7 SPAN STL GIRDER STRUCTURE

No.	Date	Revision	By
STATE OF WISCONSIN DEPARTMENT OF TRANSPORTATION DIVISION OF HIGHWAYS			
STRUCTURE B-13-952			
UNIVERSITY AVE OVER OLD MIDDLETON RD			
County	DANE	Town/City/Village	MADISON
Design Spec.	AASHTO 1974 REV. TO 1972	Load	H.S. 20
Designed	RTK	Drawn	RTK
By	JDB	Checked	JDB
By	D.R.S.	Planned	JDB
Approved	W.A. Kline Chief Bridge Engineer	Date	2-21-77
GENERAL PLAN			SHEET 1 OF 18
			X57690

1	4/25/77			828
No.	Date	Revision		By
STATE OF WISCONSIN DEPARTMENT OF TRANSPORTATION DIVISION OF HIGHWAYS				
STRUCTURE B-13-952				
Const. Spec.	1975	Drawn By	D.R.S.	Plans Checked K.T.V.
CROSS SECTION & QUANTITIES			SHEET 2 OF 13	
			X57691

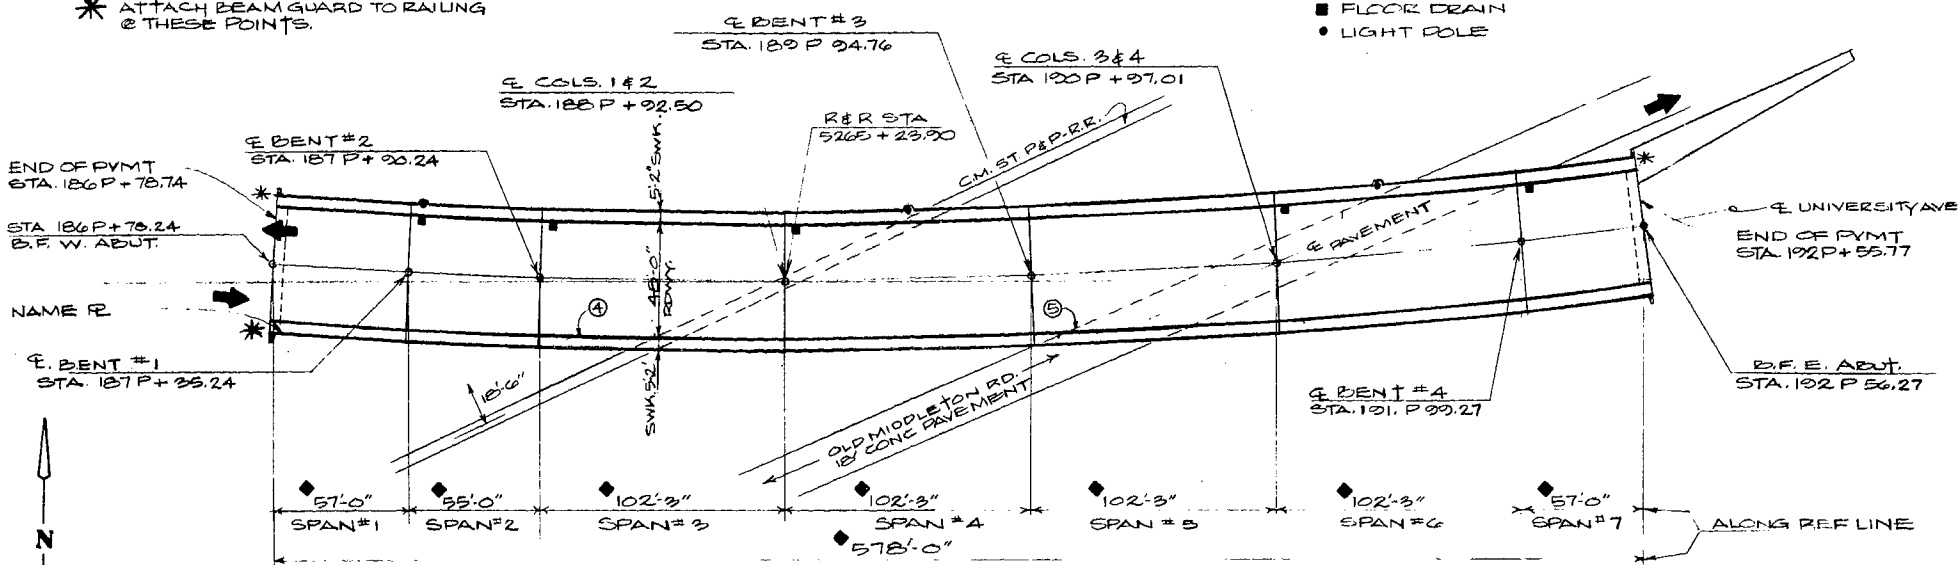
* ATTACH BEAM GUARD TO RAILING
@ THESE POINTS.

CROSS SECTION THRU ROADWAY SHOWING
NEWLY IMPLEMENTED HAUNCHES

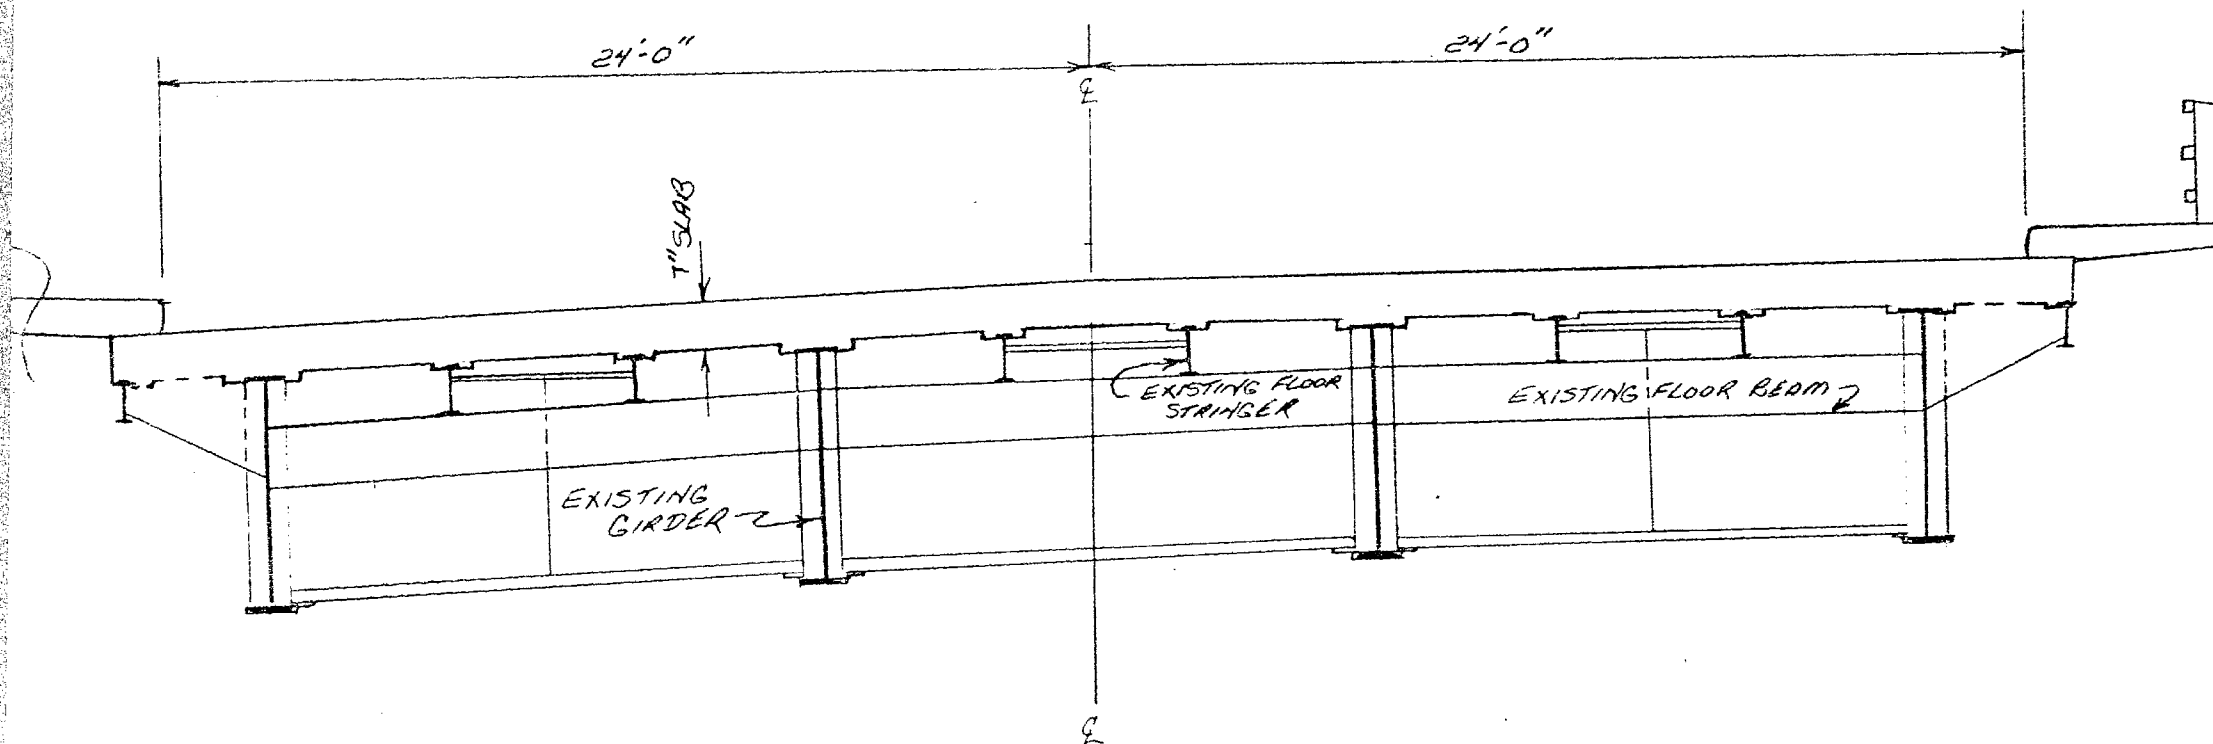
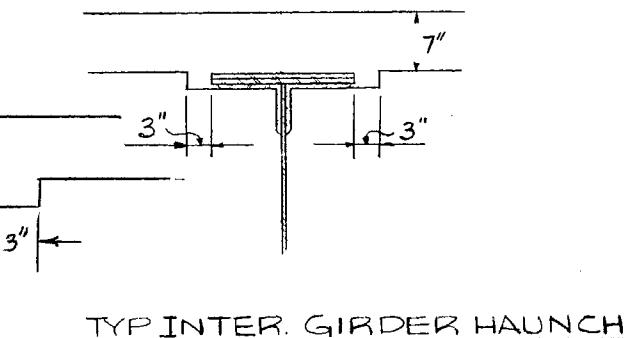
- NOTE! ABOVE X-SEC. of DECK REVISED TO SHOW NEW HAUNCHES. ~~REVISIONS TO~~

PROJECT/STRUCTURE NO. B-13-952	DATE 8-9-77
NAME OF ROAD	DATE
TITLE REPAIR TO CROSS GIR.	DATE
STAGES 1 STAGES.	DATE

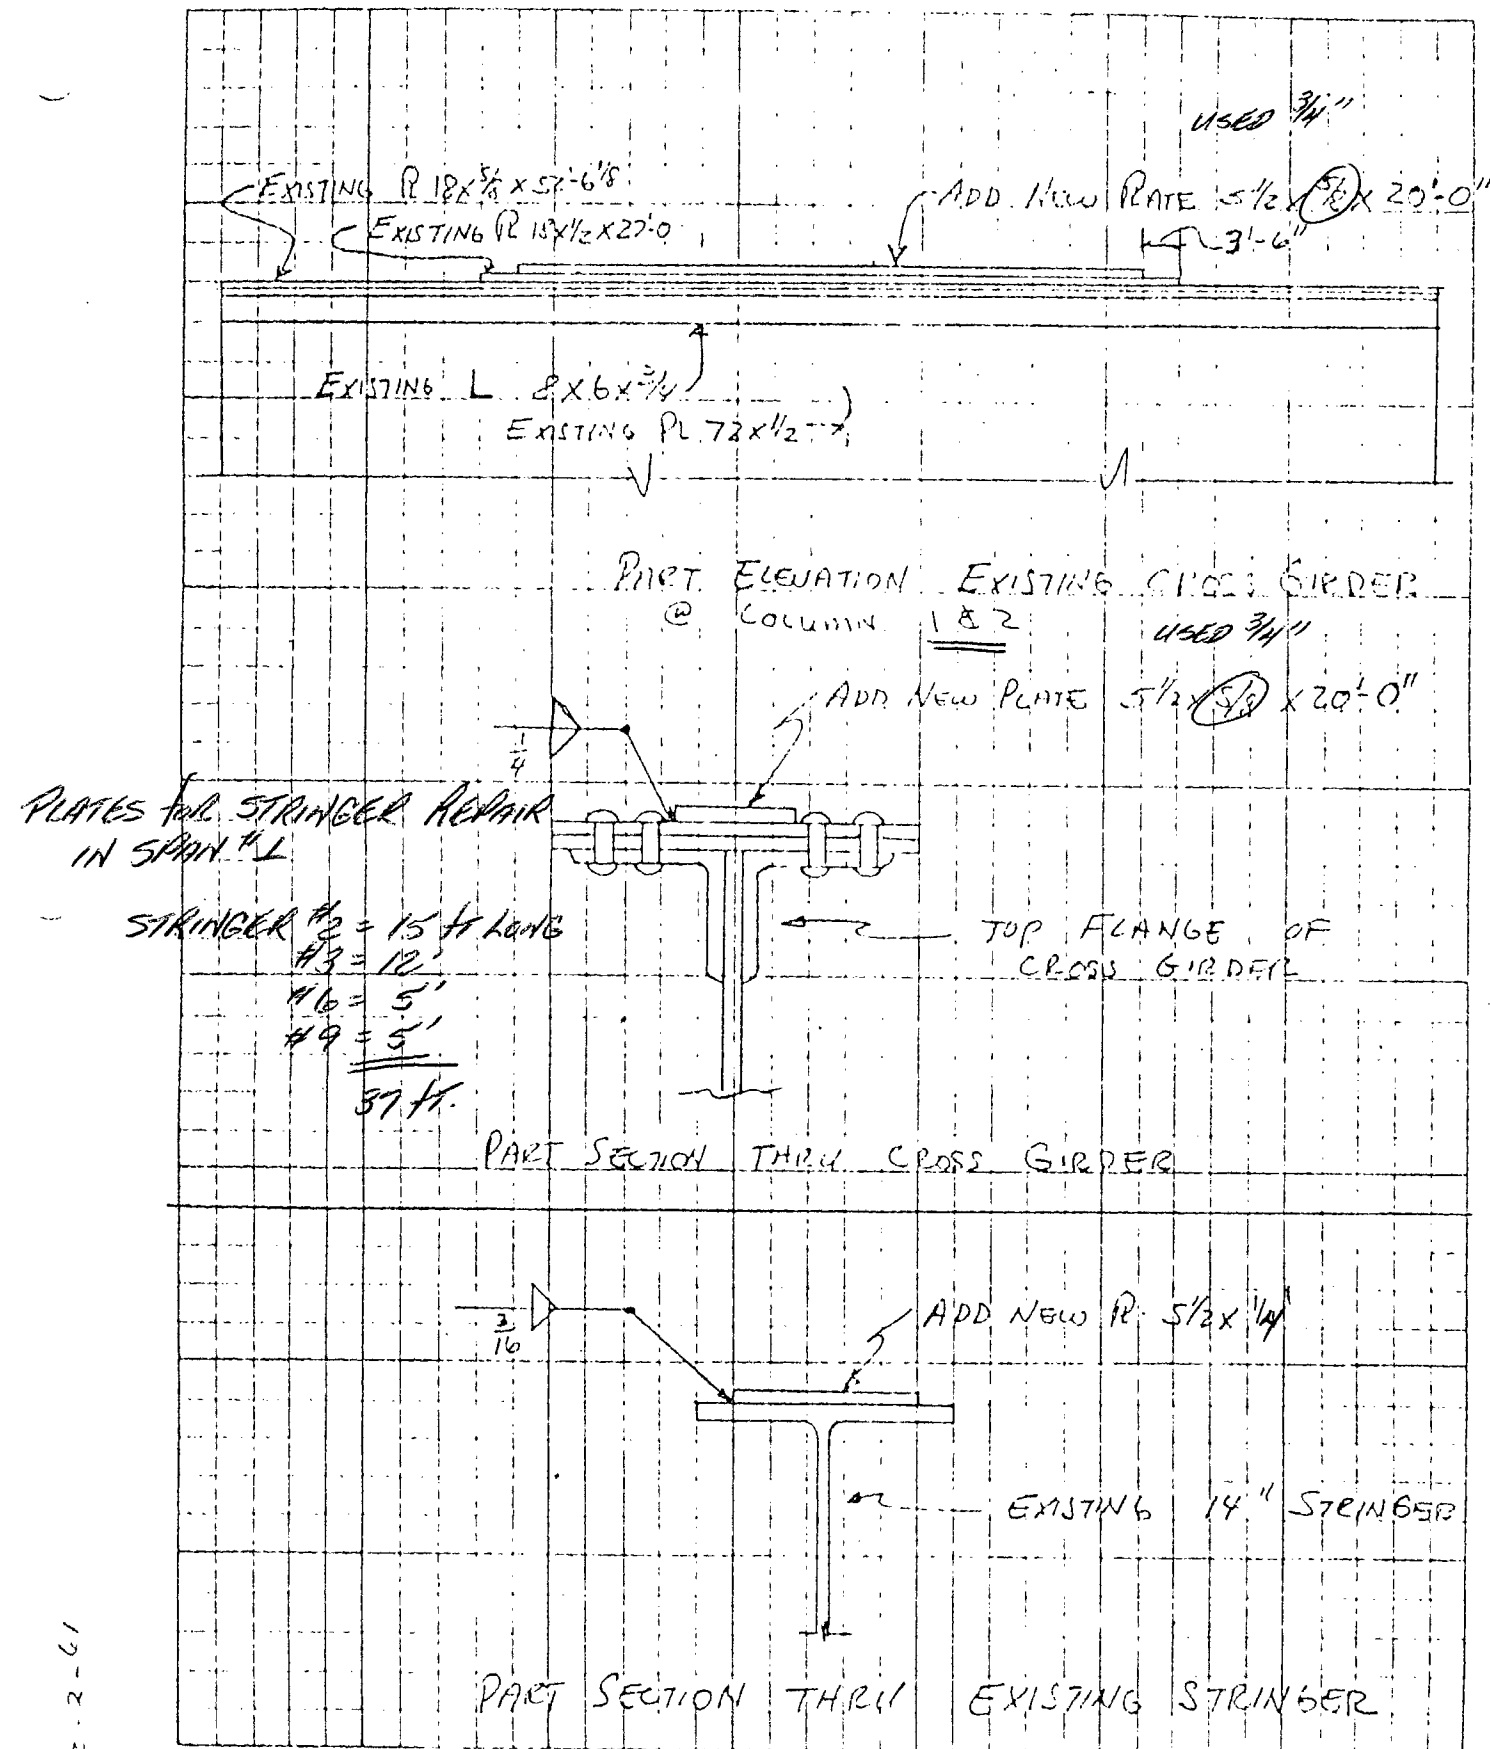
ROCKER EXPANSION BRG.
LOCATIONS TOTAL QTY (28) TO BE
RESET.

LOCATION OF GROUNDED EPOXY BARS FOR STRUCTURE
B-13-952 ON UNIVERSITY AVE. GROUNDED PER SPECIALS

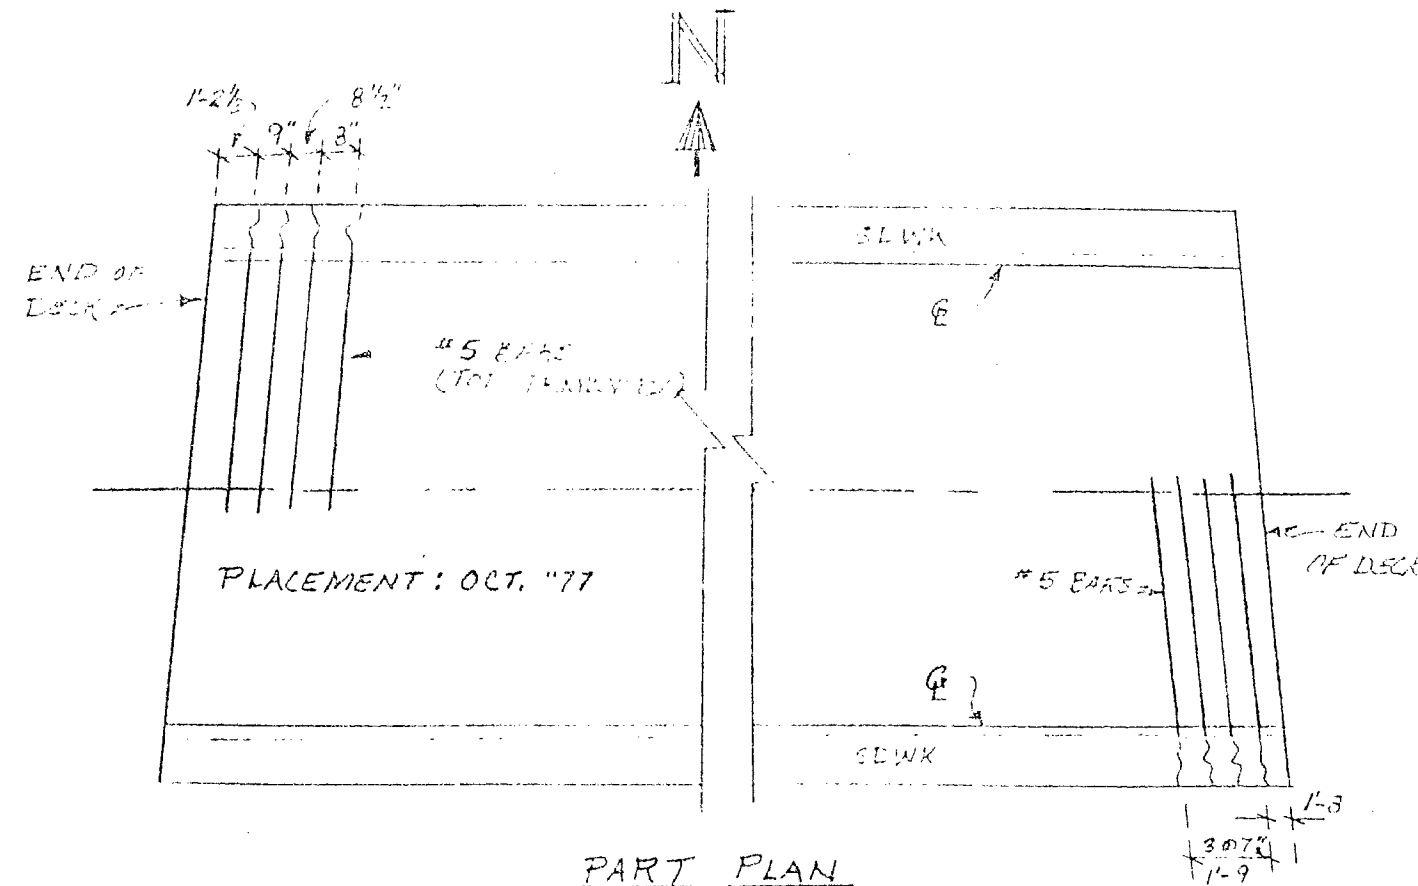
NOTE: 3M EPOXY COATED #5 BARS EXTEND
 APPROXIMATELY 24' FROM $\odot$ INTO RDWY.
 GROUND INSERTS ARE IN SEQUENCE
 WITH BAR LOCATIONS.
